**Re: R9 Ranch Modeling Results – Revision 2**

Attached is the revised report on the R9 Modeling results. During their review of the model files and the R9 Ranch Modeling Results provided by Burns & McDonnell (BMcD) to DWR on February 13, 2018, Balleau Ground Water, Inc. (BGW) identified a technical error in the operation of the Streamflow Routing Package (SFR) used by BMcD in preparing the modeling-results report. Due to this error, the model was not correctly routing flow from cell to cell along the river flow paths. BMcD corrected this error, completed the model runs with the SFR package operating correctly, and revised the modeling results report to reflect the amended results.

**Re: R9 Ranch Modeling Results – Revision 2**

Figure 4  
Sustainable Pumping Range  
with Reasonable Water Level Change  
1991 - 2007 Simulation

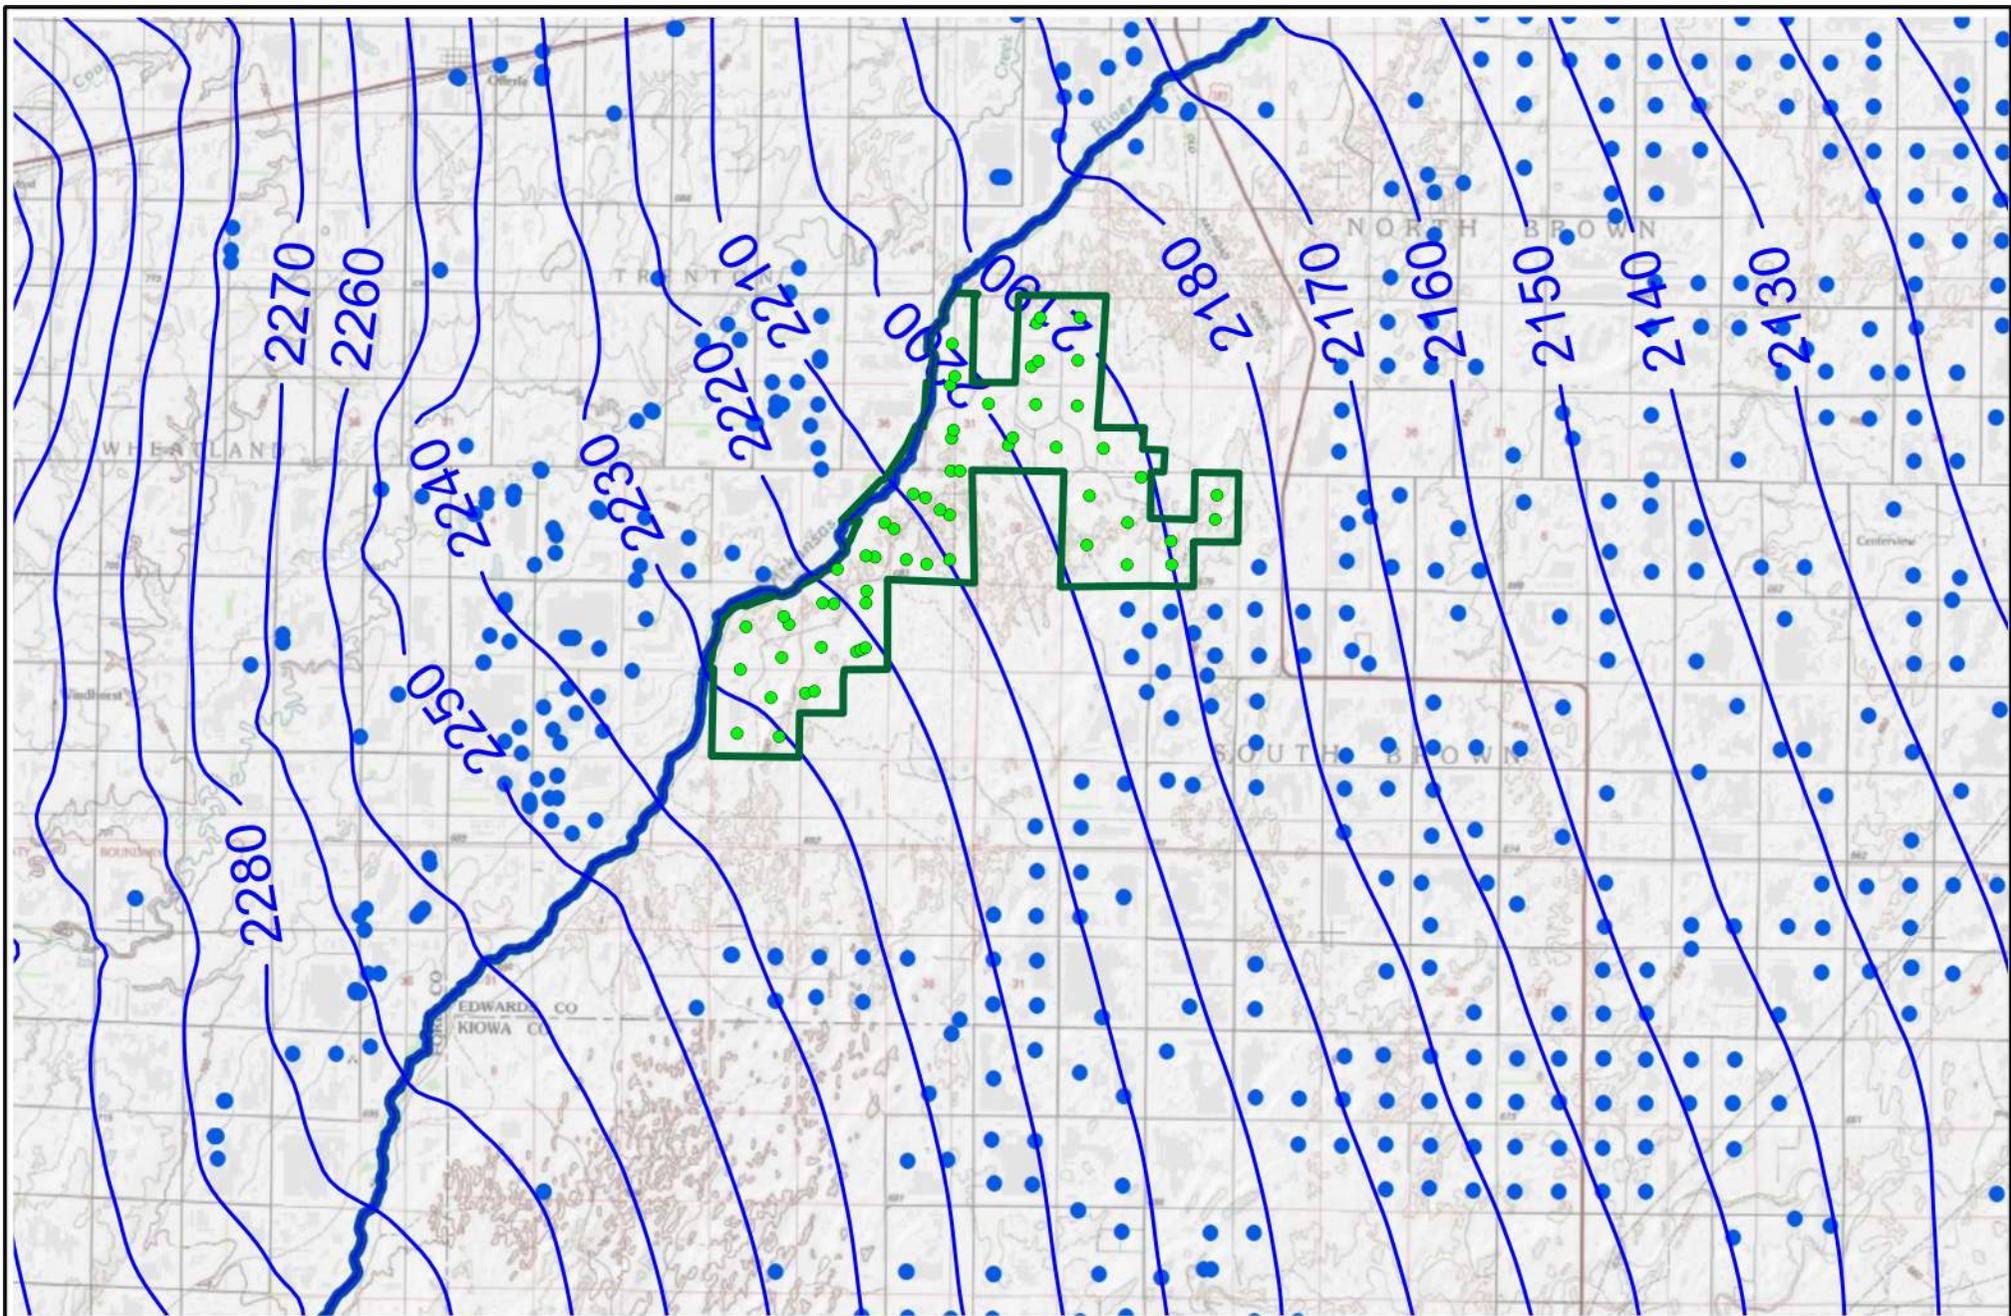
1. The text describing Figure 4 on page 5 was revised to note that at 4,800 acre-feet of municipal pumping the water level drop is 0.2 feet instead of 0.6 feet as originally reported. Figure 4 was also revised accordingly.
2. Table 1 was revised to account for the corrected model runs.
3. On Page 7, the discussion of the differences between the Scenario 2 and Scenario 1 output was revised to reflect the new model results.
4. The text describing Figure 6 on pages 7–8 was revised to state that there is only 0.3 feet of additional drawdown on the Ranch, instead of 0.5 feet of drawdown as provided in the original report. Figure 6 was revised accordingly.
5. Table 2 was updated in accordance with the revised model runs.

Figure 9

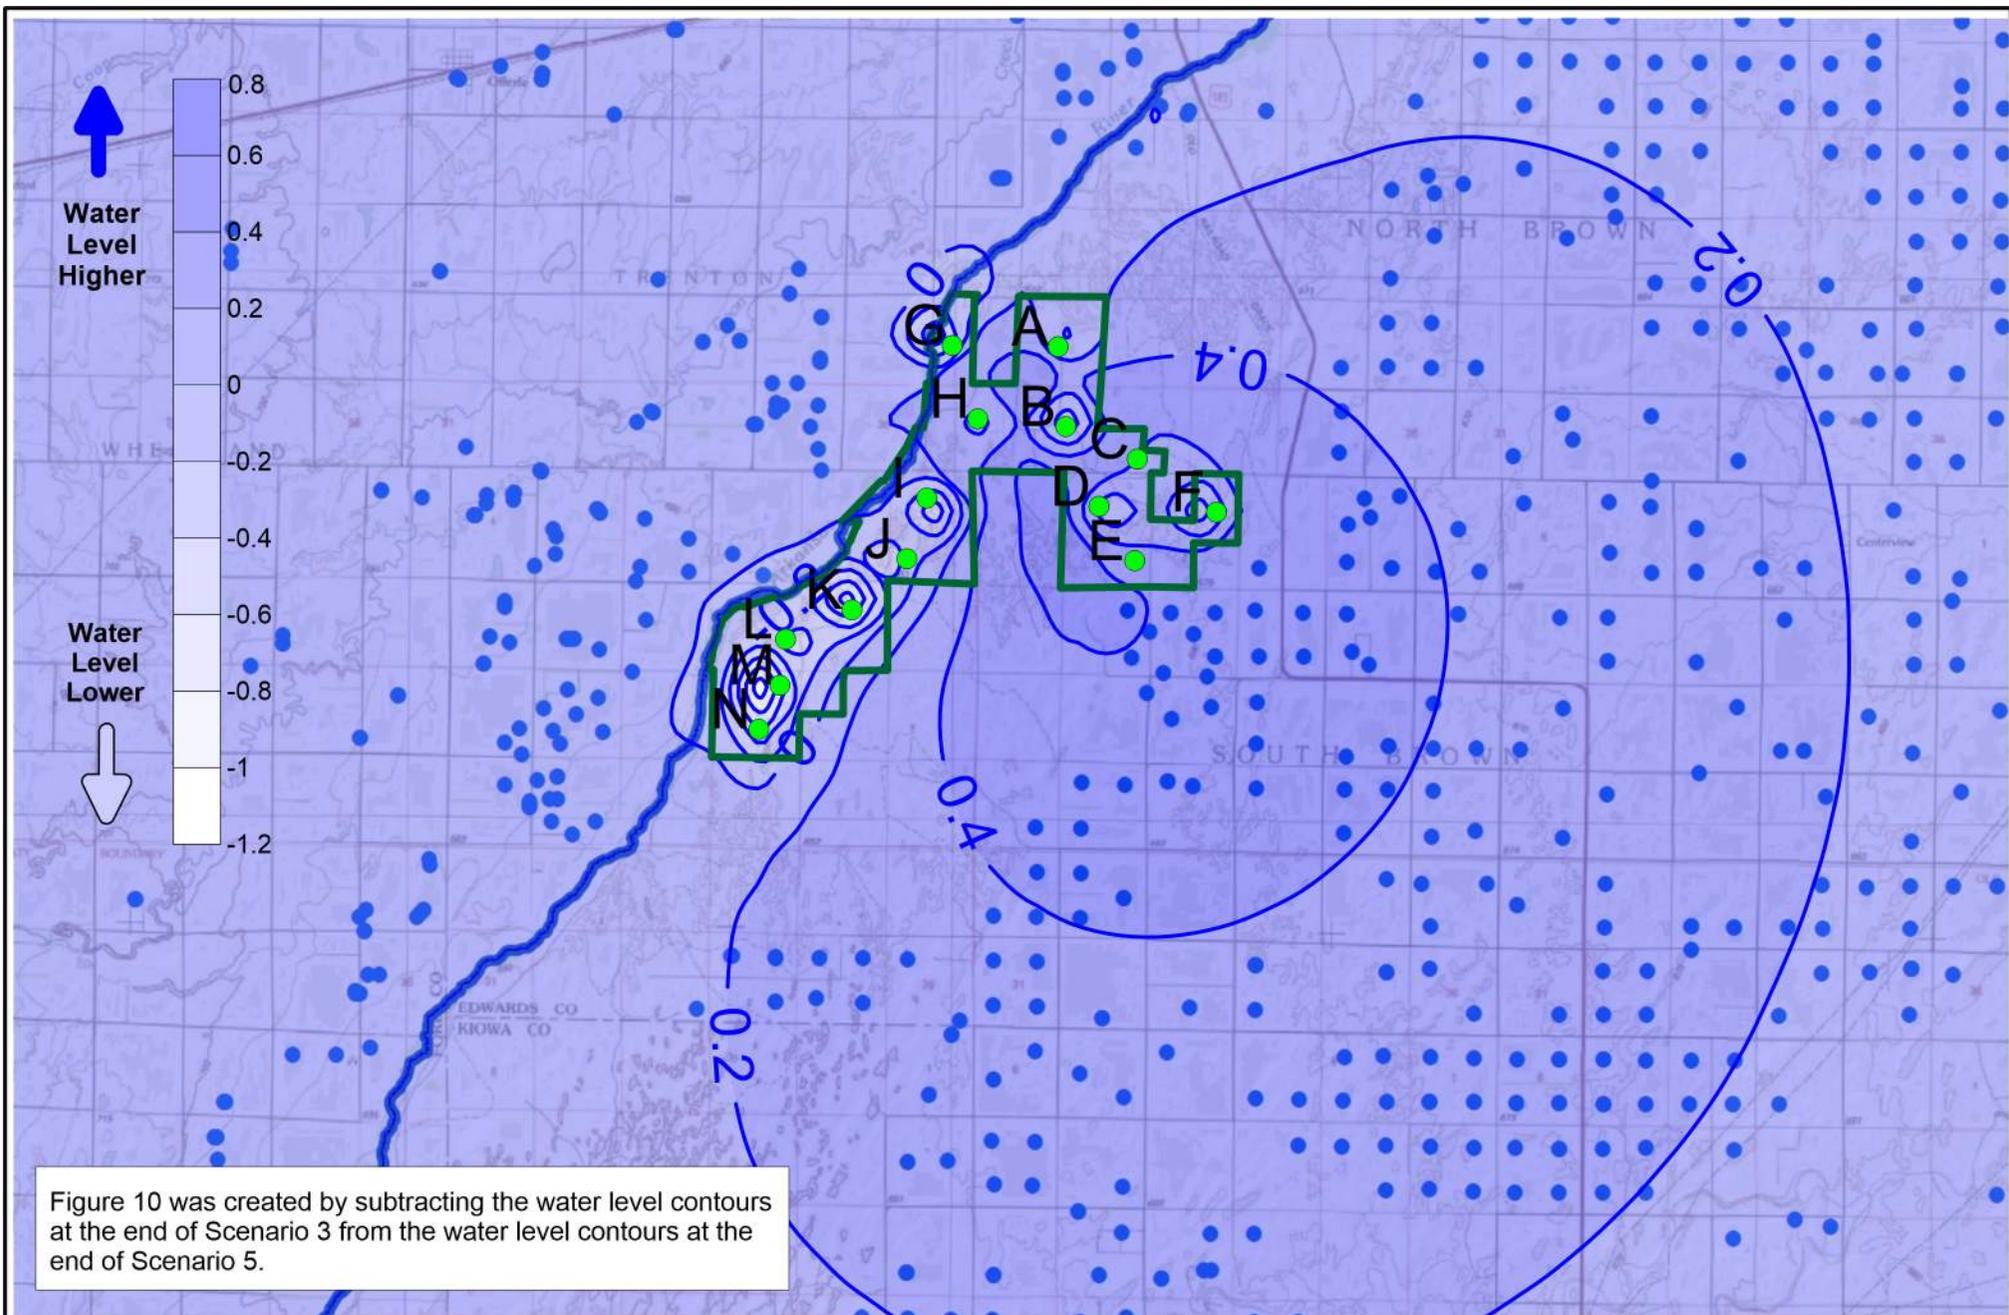
6. The discussion of the results of the Scenario 3 baseline 51-year run on pages 10 and 11 was revised.
7. The discussion of the differences between Scenario 3 and Scenario 4 was updated on page 11.
8. Figure 9 was revised and the discussion of Figure 9 on page 11 was updated to reflect that the drawdown on the Ranch was reduced to 0.4 additional feet (from 0.7 feet) in the northeastern portion and to 0.8 feet (from 1.5 feet) in the southwestern portion.
9. The comparison of the results of Scenario 5 with Scenarios 3 and 4 on page 12 was revised.
10. Figure 10 was revised.
11. The discussion of the results of Scenario 6 were revised on page 14.
12. Figure 11 was revised.
13. Figure 13 was revised.
